Access Compliance Report

Public Rights-of-Way

(Curb Ramps)

Intersection ID: 48582	Main Street: WATERLILY_LN	Cross Street: SWEET_FLAG_CT	Location: SE
ADA ID: 4AAFF41B5DB2	Ramp Type: Perp	Initial Pass/Fail: Pass	Overall Compliance: No
		Severity Score: 0.25	
Codes/Mitigation Info/Possible Solution		Field Measurements/Component Compliance

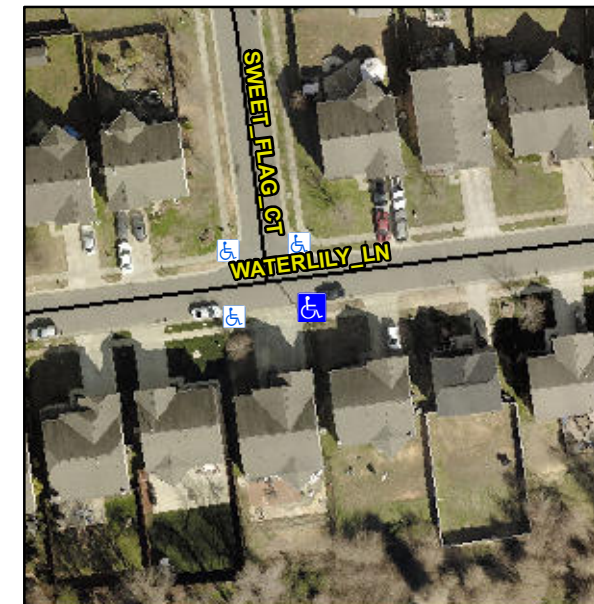
Not Found, R304.2.2-Perp, R304.3.2-Para, R305.2

Compliance	Description	Data	Compliance	Description	Data
N/A	Ramp Length (in)	49.0	Yes	Ramp Slope (%)	7.1
Yes	Ramp Width (in)	48.0	Yes	Ramp XSlope (%)	2.2
N/A	Flare Type LT	Sloped	N/A	Flare Type RT	N/A
N/A	Flare Slope LT (%)	7.0	N/A	Flare Slope RT (%)	3.7
N/A	Flare Traversable LT?	No	N/A	Flare Traversable RT?	No
Yes	Landing Length (in)	49.0	Yes	DWS Provided?	Yes
Yes	Landing Width (in)	67.0	Yes	DWS Contrast?	Yes
No	Landing Slope (%)	2.4	Yes	DWS Length (in)	24.0
Yes	Landing X Slope (%)	2.3	Yes	DWS Full Width?	Yes
N/A	Landing Curb? (Y/N)	No	No	DWS Offset (in)	3.0
N/A	Shared Landing?	No			
Yes	Gutter Ponding?	No	Yes	Gutter Slope (%)	0.6
Yes	Gutter Lip Ht (in)	0.0	Yes	Gutter X Slope (%)	2.8
N/A	Painted X Walk1?	No	N/A	Painted X Walk2?	N/A
	X Walk 1 Direction	To N		X Walk 2 Direction	N/A
N/A	X Walk 1 Width (in)	N/A	N/A	X Walk 2 Width (in)	N/A
	X Walk 1 Slope (%)	2.3		X Walk 2 Slope (%)	N/A
	X Walk 1 X Slope (%)	2.9		X Walk 2 X Slope (%)	N/A

N/A	Ramp inside XWalk1?	N/A	N/A	Ramp inside XWalk2?	N/A
	Road Slope (%)	N/A	N/A	Clear Space?	Yes
	Road X Slope (%)	N/A	N/A	Clear Space to XWalk (in)	N/A
Yes	Any Obstructions?	No	Yes	Storm Grate/Utility Hazard?	No
	Obstruction Type			Storm Grate/Utility Type	
		N/A			N/A
			Yes	Surface Condition? (G/P)	Good

Remove & Replace Entire Ramp.
